25 June 2021  
Document No. 60.00741.05 LTR4R1.DOCX

**Consultant Advice Notice**  
**Kariong Sand and Soil Supplies**  
**Noise & Vibration Impact Assessment**

Waves Acoustic Consulting Pty Ltd (Waves Consulting) provided a Noise & Vibration Impact Assessment (Document No. 60.00741.05 RPT1R3.DOCX) as part of the EIS for the Kariong Sand & Soil Supplies Facilities Upgrade, 90 Gindurra Road, Somersby, NSW.

Figure 1. Proposed Fully Enclosed Crusher and Mulcher Sheds

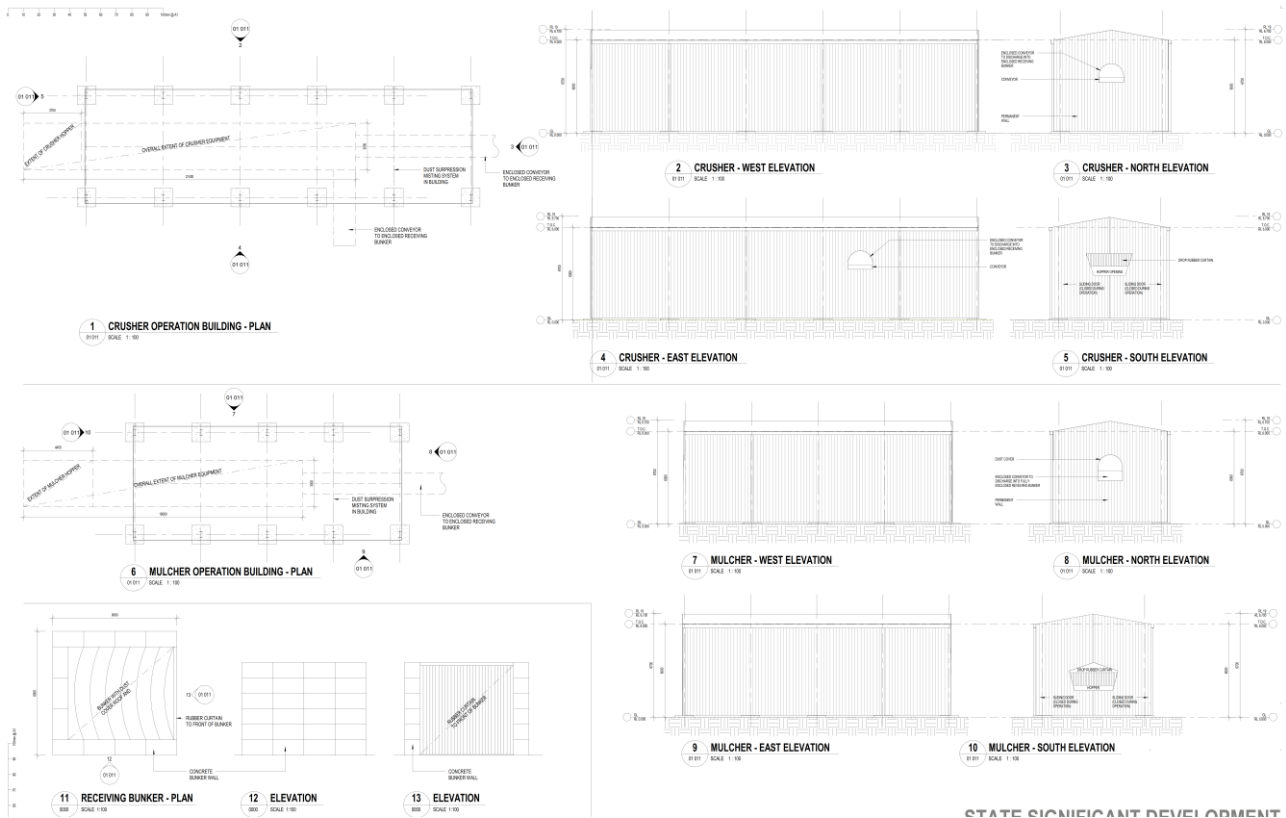
- The noise model in the EIS does not include the latest design information for the proposal. The EIS modelled open-ended sheds around the crusher and mulcher plant; however, the latest design shows the crusher and mulcher sheds are to be fully enclosed.
- The noise model in the EIS has used source noise levels for the main items of plant which are too conservative.
- The noise model in the EIS has not applied corrections for impulsive noise events as per AS1055:2018. While it is noted that the NSW NPI dated 2017 does not specifically require assessment of impulsive noise events the DPIE will be looking for impulsive noise assessment in all future projects.

Figure 1 below illustrates the fully enclosed crusher and mulcher sheds used in the new noise model.
